Project Name: 702 NE 3rd Avenue (2020-023)

Request: Certificate of Appropriateness, Class V Site Plan, Landscape Plan, & Elevations

HISTORIC PRESERVATION BOARD STAFF REPORT

Meeting	File No.	Application Type
January 15, 2020	2020-023	Class V Site Plan & Certificate of Appropriateness

PARKING PLAN, SCALE: 1" = 20'

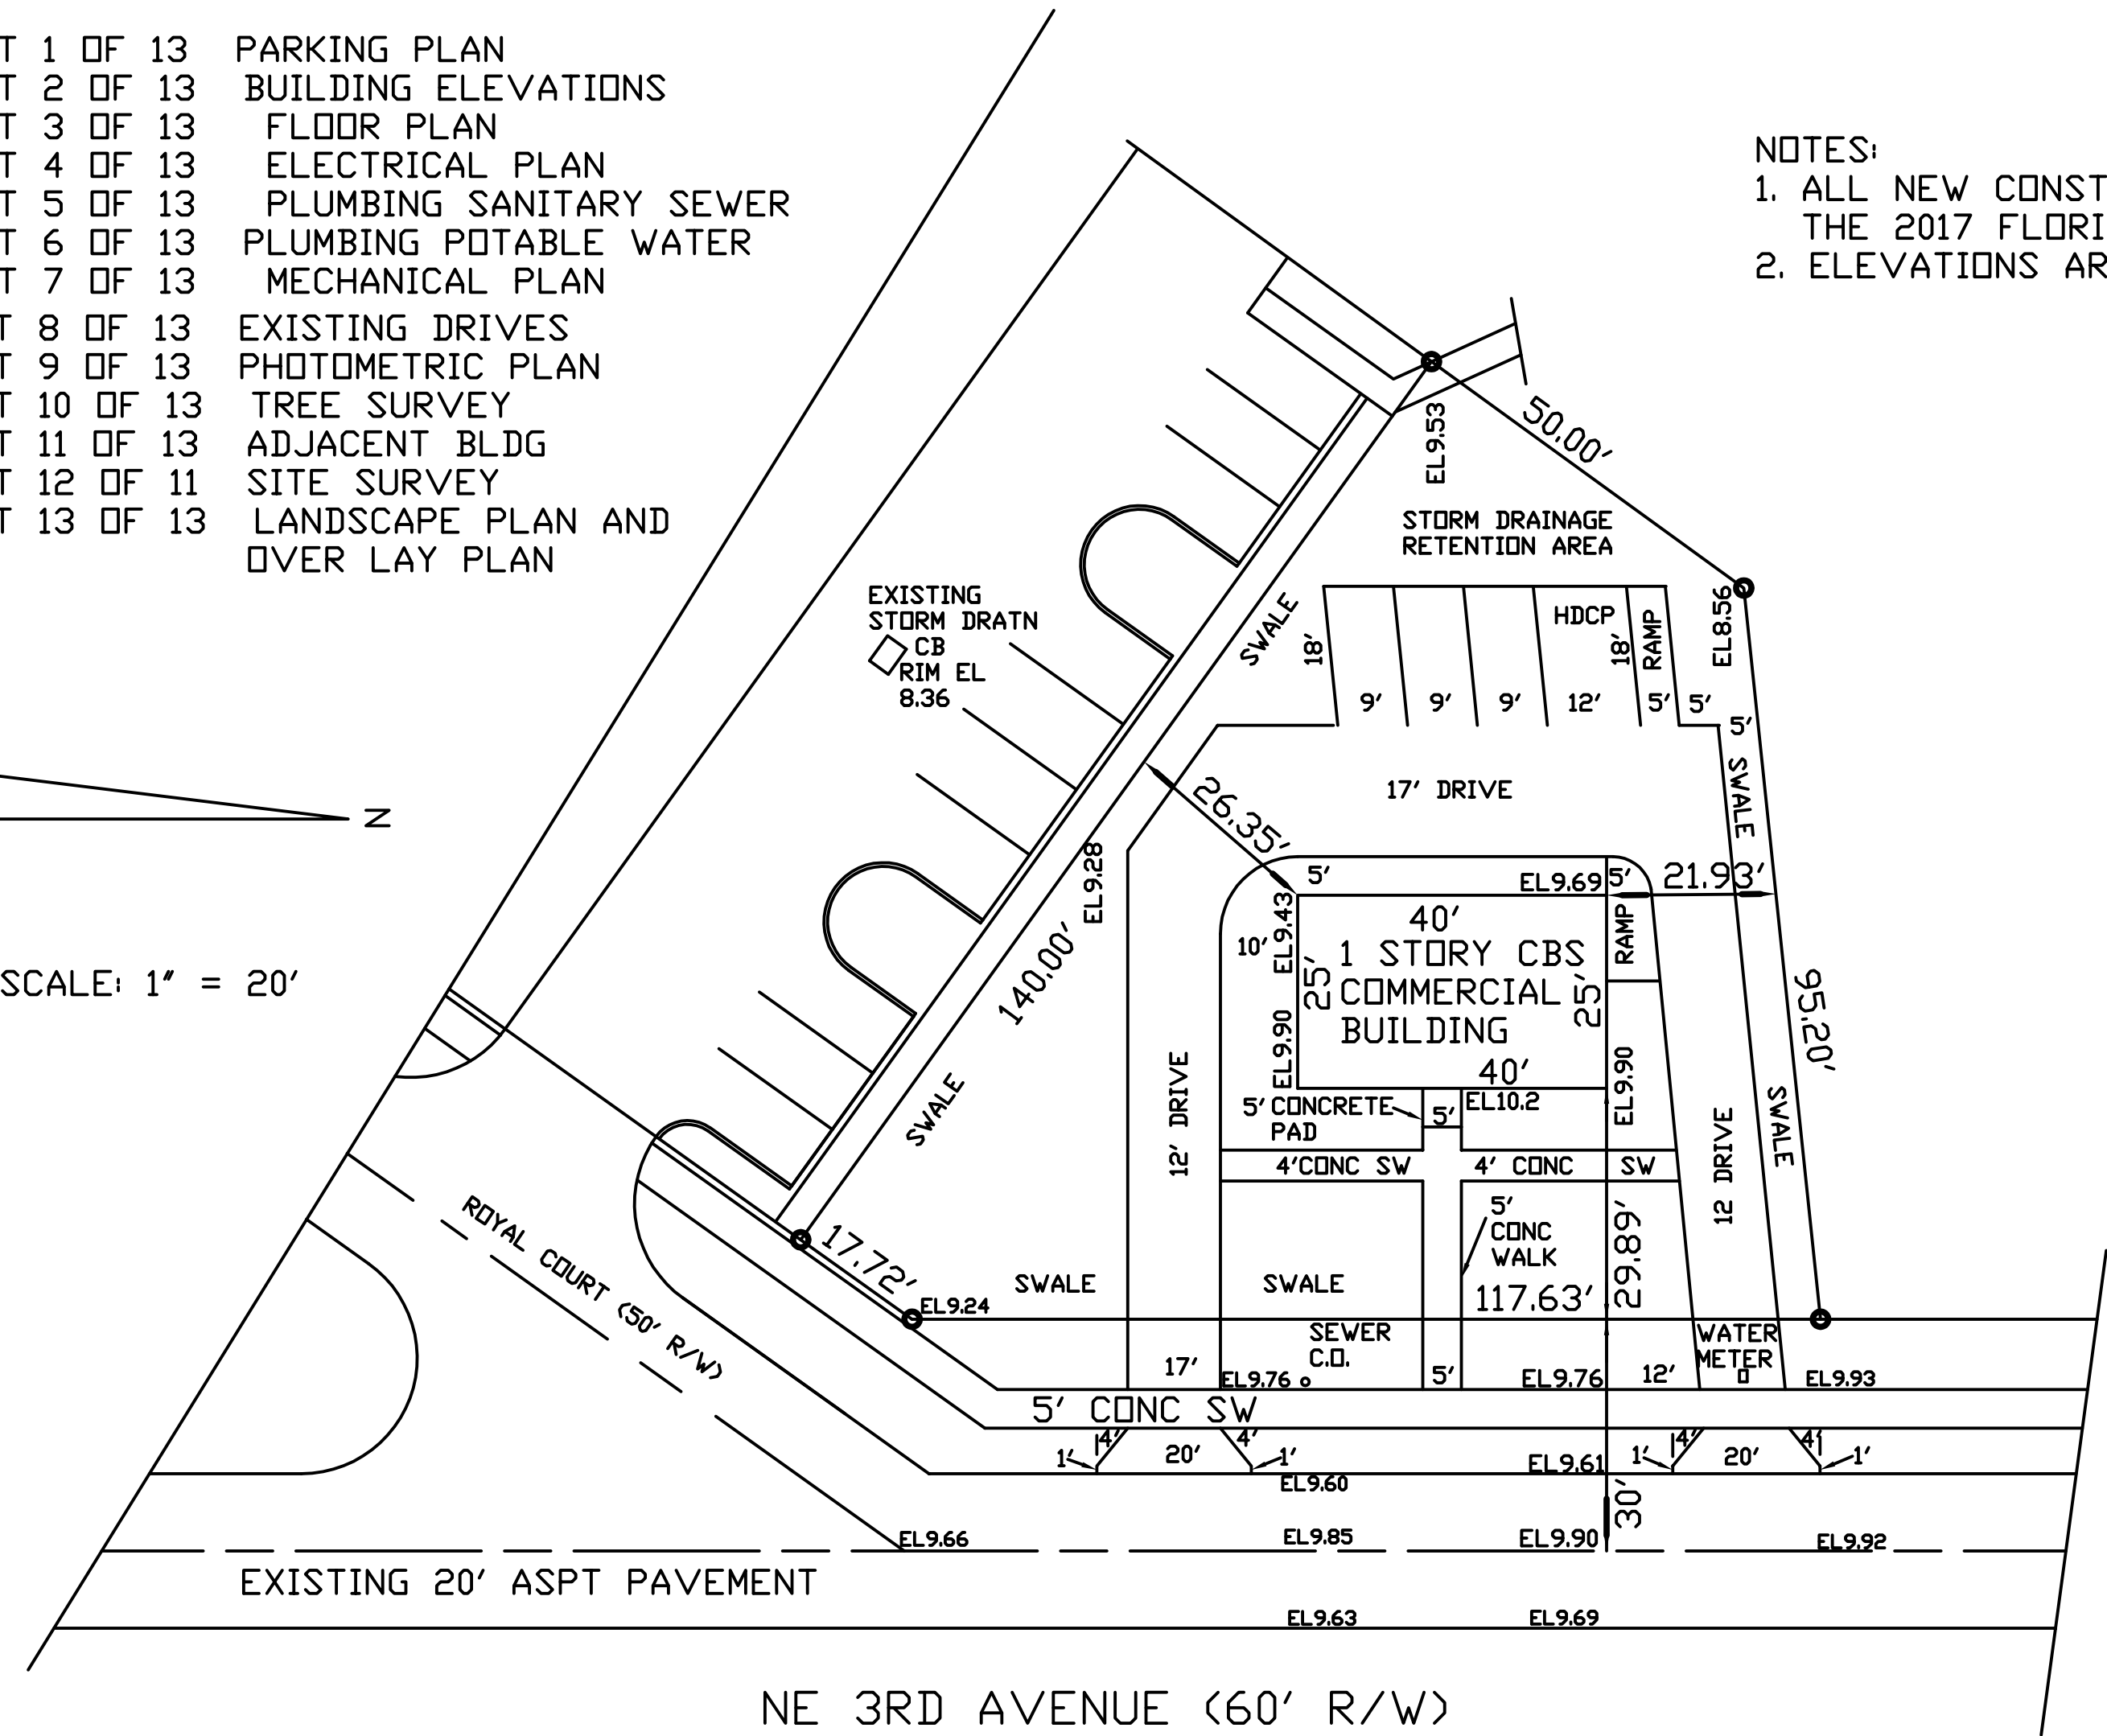
*A Site Plan Technical item is included requiring the existing and proposed open space and lot coverage calculations (square footage and percentages) are provided on the site plan.
